Interactive comment on “Hydrological evaluation of open-access precipitation data using SWAT at multiple temporal and spatial scales” by Jianzhuang Pang et al.

Response to Referee Comments:Reviewer#1

Fig. 1. Spatial variation of annual precipitation at sub-basin scale for (a) Gauge (b) CHIRPS and (c) CPC.

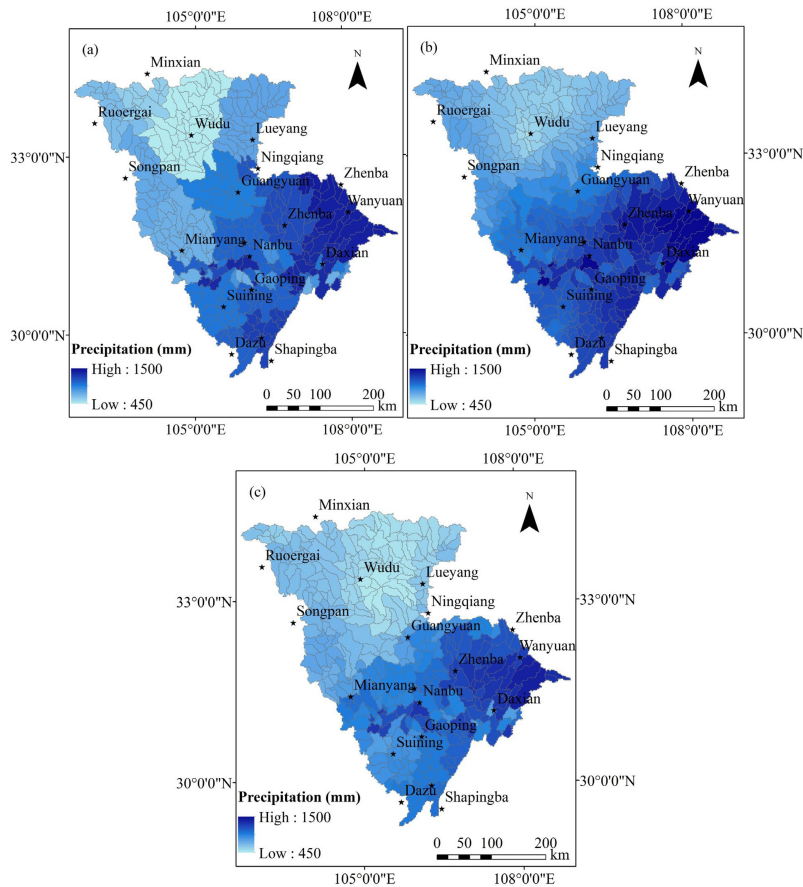
1. *The paper fails to articulate the implications of its finding (that hydrological models can give very similar model performance, with differing process behaviour, with precipitation datasets with quite different characteristics) in either the Conclusions or the Abstract. For example, Remesan and Holman (2015) study cited by the authors showed that such ‘similar’ calibrated/validated models, when subsequently run using perturbed inputs (e.g. climate change scenario), can lead to different magnitudes and directions of hydrological change due to their differing parameterization. The authors should consider how their findings can guide modelers in the use of these different precipitation datasets for the hydrological modelling of the current and future climate.*

L435-437 – “. . . Moreover, precipitation in the watershed’s upstream area tended to infiltrate into the land surface due to the lower precipitation detection (see Fig. 7); yet when the river flow converged in the watershed’s downstream area, the surface flow increased due to the larger detected precipitation values.”

Moreover, precipitation in the watershed’s upstream area tended to infiltrate into the land surface due to the lower precipitation detection (see Fig. 7); yet when the river flow converged in the watershed’s downstream area, the surface flow increased due to the larger detected precipitation values. The results of these findings demonstrated that although the river runoff simulated by the three models are basically consistent,

hydrologic components exhibited distinct behaviours due to the different features in precipitation detection. CHIRPS has a stronger ability to recognize heavy rain and tends to produce more surface runoff, while CPC's strong ability to identify light rain produces more lateral flow. As such, multi-objective calibration approach would be recommended for flood prediction in future climate. Tuo et al. (2018) use water yield (WYLD), snow water equivalent (SWE), combining WYLD and SWE as objectives to for parameter calibration and optimization in the SWAT model, and verified the effectiveness of the multi-object procedure.

Fig. 2. Observed and simulated discharges at the outlet of JRW at monthly scale using precipitation inputs of Gauge, CHIRPS and CPC, respectively.

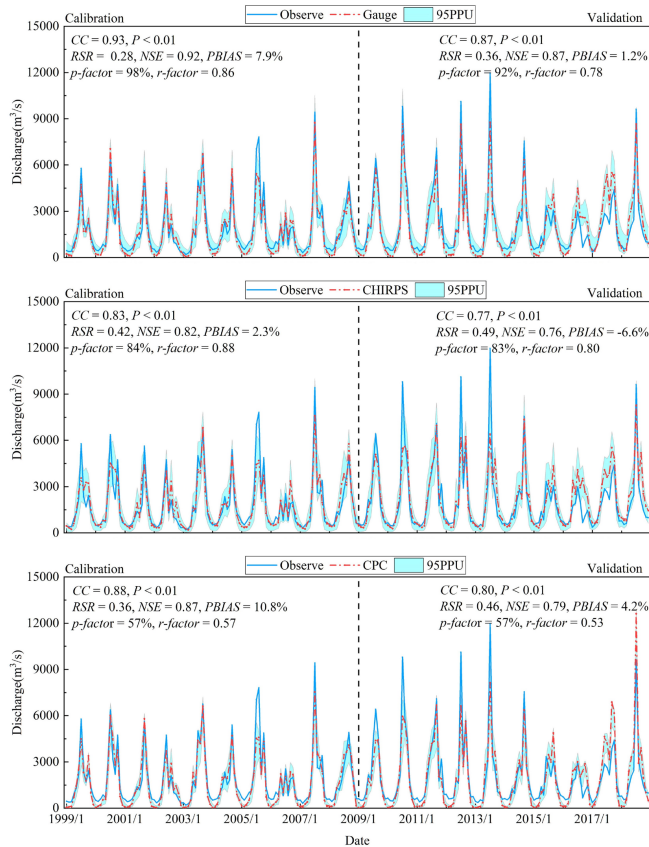
2. Given that the authors are simulating a 159,000km² catchment using a single flow gauge for calibration / validation, there is huge equifinality in their results. Given that they used the SUFI-2 / SWATCUP, I would have expected some assessment and discussion of the uncertainty in their model results.

Based on the model performance classification scheme designed by Moriasi et al. (2007), Gauge and CHIRPS achieved “very good” performance for both the calibration and verification periods, **although the Gauge model attained the highest *NSE* (0.92 for calibration and 0.87 for validation) values and lowest *RSR* (0.28 and 0.36) value, while CPC only reached the level of "Good" due to higher *PBIAS* (10.8) (Fig.9).** The underestimation of the peak flows during flood seasons, would be the main reason of the lower *NSE* values of the two OPPs inputs. **Further, among all the three models,**

the model with Gauge inputs performed best in uncertainty analyses (p -factor = 98%, r -factor = 0.86 for calibration and p -factor = 92%, r -factor = 0.78 for validation), which is followed by the model using CHIRPS as input (p -factor = 84%, r -factor = 0.88 and p -factor = 83%, r -factor = 0.80). Using CPC datasets as precipitation inputs resulted in the highest degree of uncertainty level (p -factor = 57%, r -factor = 0.57 and p -factor = 57%, r -factor = 0.53), which fails to reach a preferable level.

Fig. 4. Water balance components for all sub-basins derived from SWAT models using precipitation inputs of (a) Gauge (b) CHIRPS and (c) CPC at monthly scale and (d) Gauge (e) CHIRPS and (f) CPC at daily scale

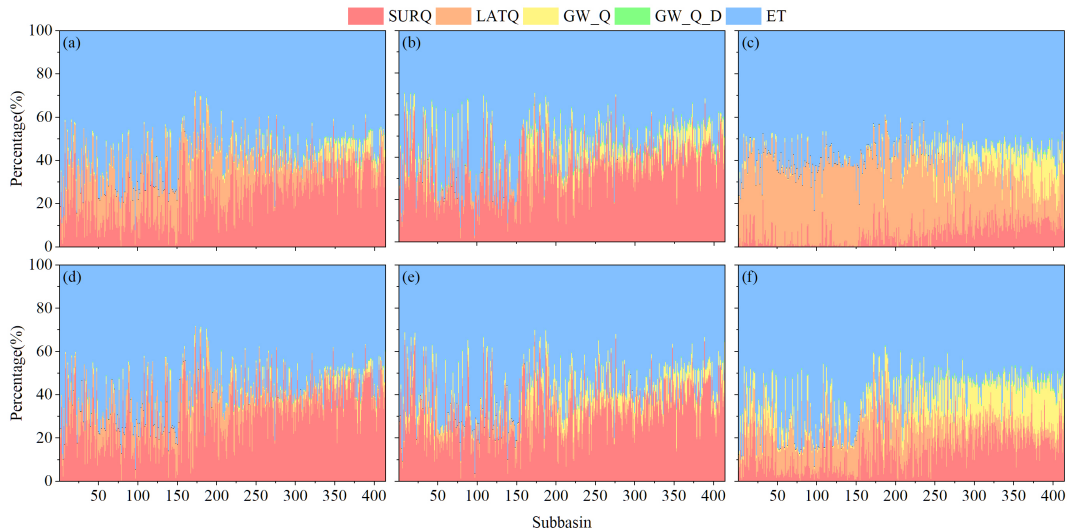
3. The paper provides three sets of SWAT output analyses – monthly, daily and daily aggregated to monthly. However, SWAT is a daily model so the monthly SWAT outputs are themselves an internal aggregation of its daily outputs; so the presentation and description of the daily aggregated to monthly outputs (L439-448 and Figures 12 and 13) are meaningless and should be removed.

(2) With differing parameterizations, different precipitation inputs tend to derive completely different hydrological component amounts at different time scales (Fig. 16 & Table 5).

Thus, we calculated the water balance component portions, Q_{surf} , Q_{lat} , Q_{gw} , and ET , for all the JRW sub-basins. With differing parameterizations, different precipitation inputs tend to derive completely different hydrological component amounts at different time scales (Fig. 16 & Table 5). At monthly scale, all three models, with Gauge, CHIRPS and CPC as inputs, have similar ET portions, which account for above 54%. The major components of Gauge model are SURQ and LATQ, accounting for 25.92 % and 16.72 %, respectively, the major component of CHIRPS model is SURQ, which accounts for 34.80 %, and the primary component of CPC model is LATQ, which accounts for 33.62 %. However, at daily scale, SURQ of Gauge model increased largely, reaching a proportion 32.61%, while LATQ decreased to 10.92%; LATQ of CPC model decreased and SURQ and ET increased, accounting for 14.41%, 15.60% and 58.73%, respectively; water balance components proportions of CHIRPS model slightly changed.
